AG-SB-2018-07-B-EN	S-SB-2018-07-B-EN Compliance Category:	
Applica	ability	A - MANDATORY
Aircraft type & model: Any AutoGyro gyroplane fitted with an lvoprop propeller.	Affected Serial number(s): Any AutoGyro gyroplane fitted with an Ivoprop propeller.	B – RECOMMENDED C - OPTIONAL
The maintenance manual to be referenced	I is this stated or subsequent issue.	As per AutoGyro website
containment or rectification action	GmbH either against a problem found in on, or as service information for aircraft m n 49(0)5121 88056-00, or email airworthir	odification incorporation.

Reason and overview of the Service Bulletin (cause of problem if known)

Photo of the Control Board. Connector

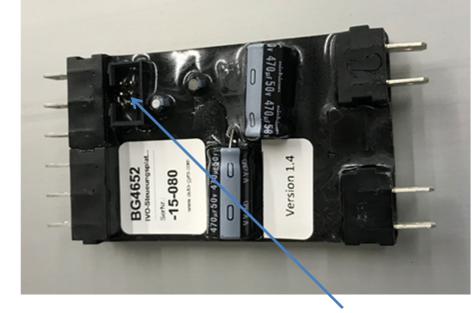
- 1. Locate the Control Board module (see photo), which is either located on the left side of the forward seat (MTO Sport) or behind the instrument panel. On some aircraft this may be easily accessible without removing the panel, on others the panel must be detached from the aircraft and pulled rearwards to give access.
